Wisconsin Department of Transportation

Proposal #08: 2235-00-74, WISC 2025006
C Oak Creek S 6th Street
Bridge Over Br Oak Creek P-40-0058
Local Street
Milwaukee County

This is Addendum No. 01, which provides for the following:

ADDENDUM NO. 01

Addendum No. 01
ID 2235-00-74
Revised Sheet 9
September 18, 2024

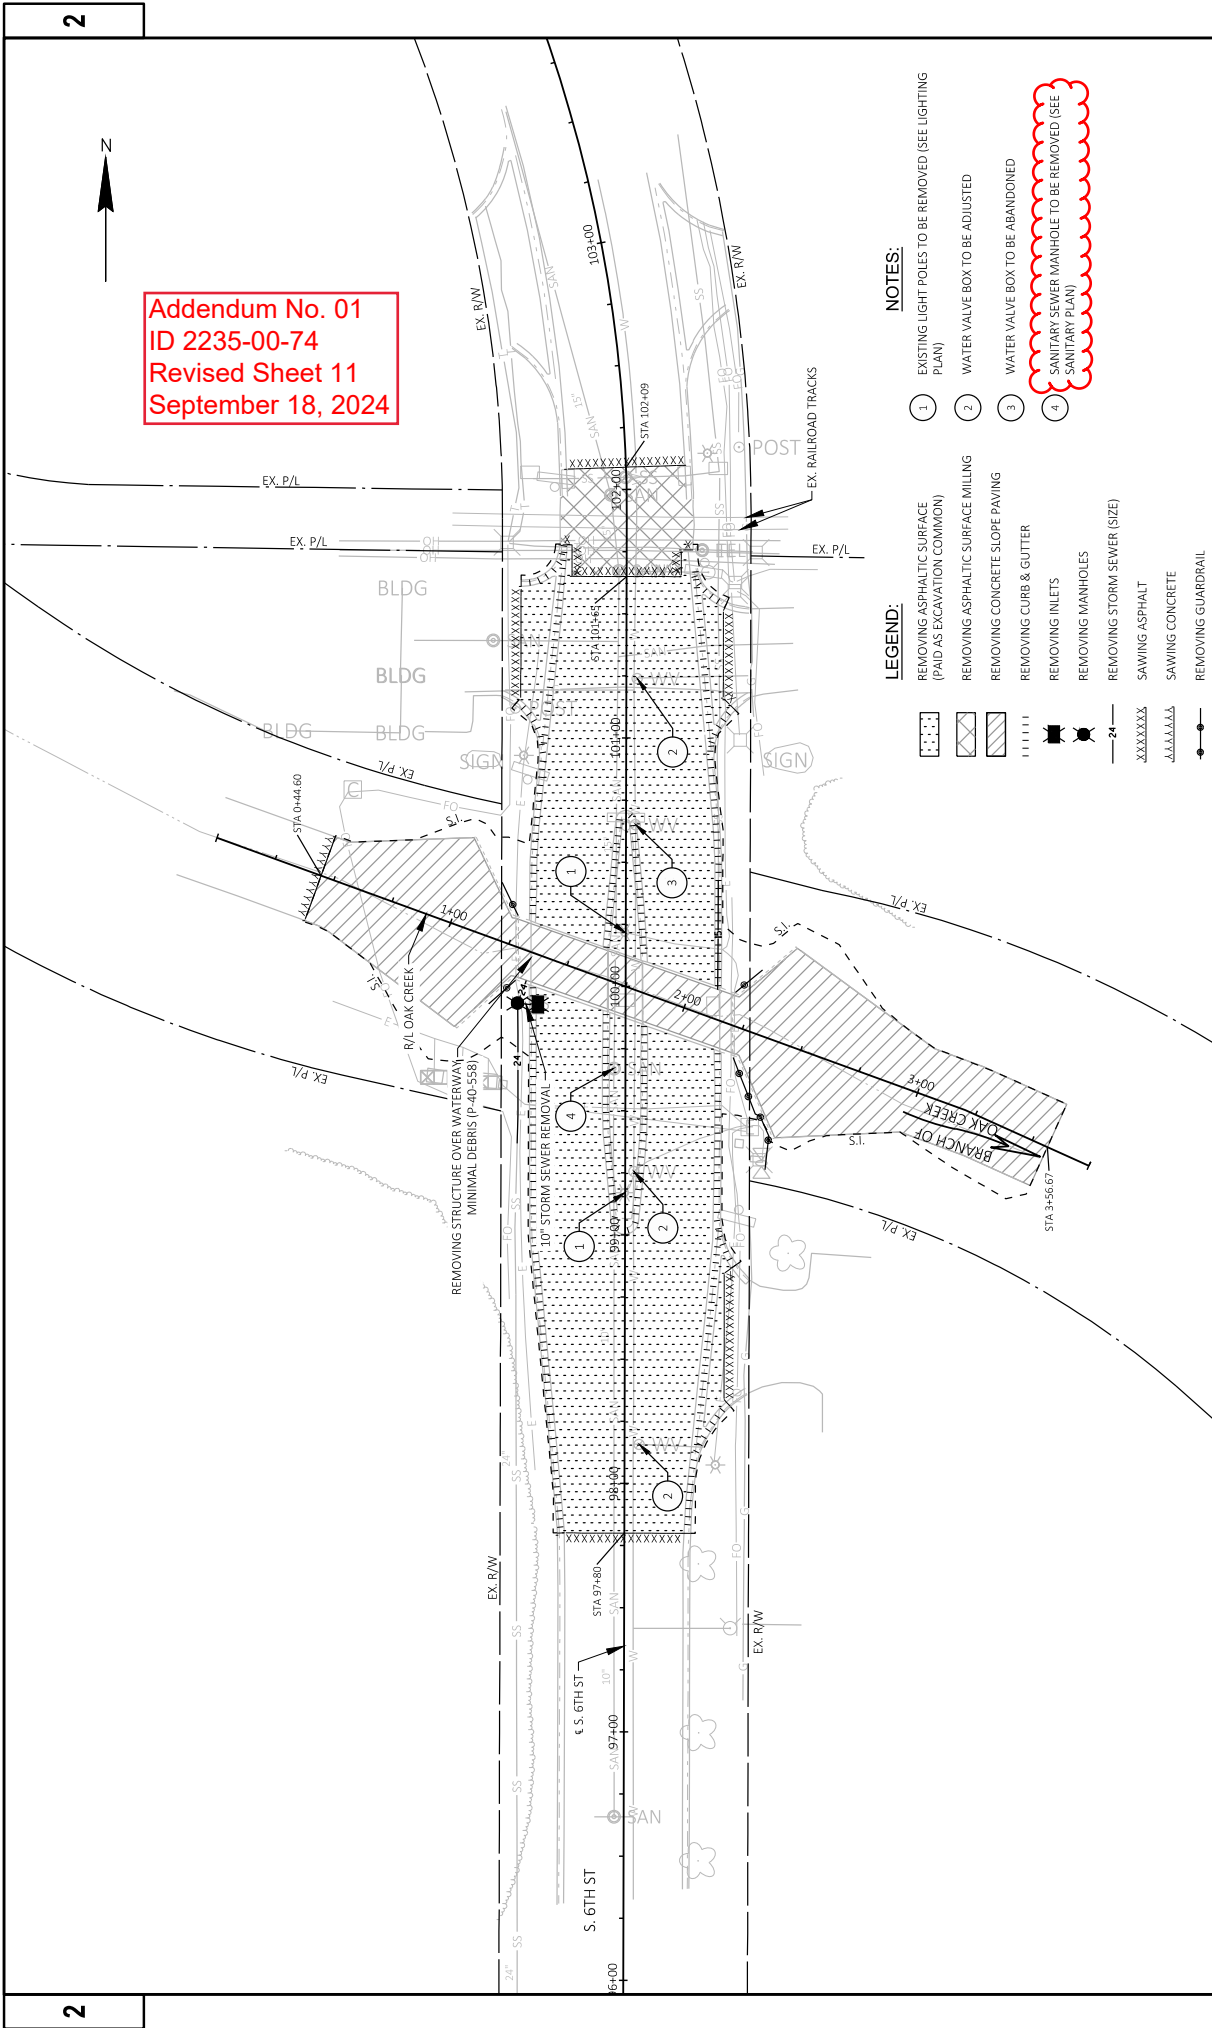
Revised Plan Sheets	
Plan Sheet	Plan Sheet Title (brief description of changes to sheet)
9	Construction Details - (Removed sanitary pipe crossing from channel profile view).
11	Removal Plan - (Revised item callout).
12	Plan Details - (Revised leader callout).
17	Sanitary Sewer Plan & Profile - (revised from relay to removal).
